BELL SYSTEM PRACTICES
Station, Installation
and Maintenance

ADDENDUM C32.506
Issue A, 2-7-46-C

TELEPHONE SETS
STROMBERG-CARLSON

Fig. 2

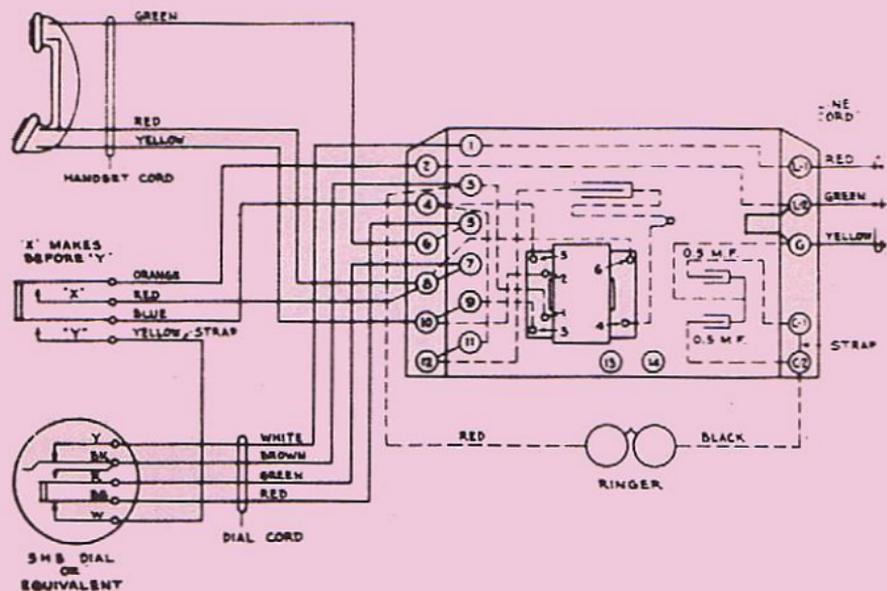
1.02 Paragraphs 3.01 and 3.02 of this addendum replace 3.01 and 3.02 of the section and Fig. 2 is added.

3.01 The connections for these telephone sets, where used in manual areas are shown in Fig.1 of the section, and, where used in dial system areas are shown in Fig.2 of this addendum.

3.02 The diagrams in Figs. 1 and 2 shows the line and ringer connections for bridging lines. Line and ringer connections for bridging and ground lines of the classes of service for which the set is used are given in Table 1.

*On bridged ringing lines strap terminal L2 to terminal G. On grounded ringing lines, omit this strap. Local ground should not be connected through to yellow mounting cord conductor on bridged ringing lines.

Note: To add dial: replace apparatus blank with 5HB dial or equivalent, connect dial cord as shown, disconnect green wire from hook switch and No. 6 terminal and add yellow wire strap between "W" terminal of dial and hook switch terminal from which green wire was removed. Tape or tie back ends of unused green wire of hook switch cord so that they will be out of the way of other wiring.
